PROJECT : Herschel		NON CONFORMANCE REPORT	
Subsystem : SMECm		Unit : SPIRE	
Model :		Identif. Structure de base # 10 Drawing ref : SPI-MEC-10-DD-01-G	
NCR occured during : Manufacture [] Inspec [] Test [X] Integ [] Other []			
NCR Title : Wrong location of the holes used to attach the clamp for the harness			
NCR Description : Wrong location (0.7mm) of the two M2.5 holes used to attach the clamp for the harness. One of the hole is half part on the rib half part on the recess			
Originator Name : G. Rousset		Date 29/06/2005	Signature : 
Cause of the NCR : Deviation during manufacture		Major []	Minor [X]
Disposition/Corrective Action :		Corrective action carried out : Name : Date :	
MRB date : 29/06/2005		MRB Minute Ref : No report	
MRB Conclusion: A counterboring dia 6mm depth 2mm will be machined in the axe of the M2.5 hole. An Inox washer (XN26TW) Ext Dia 5.5mm with a M2.5 hole in the centre will be manufactured. The washer will be glued with DP 490.

(Base n° 10)

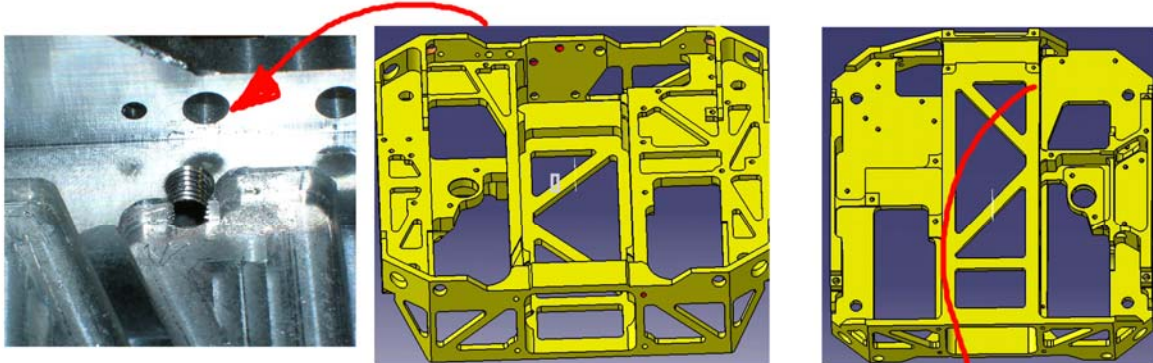
Décalage de 7/10^e des trous de fixation
de la bride serre cable
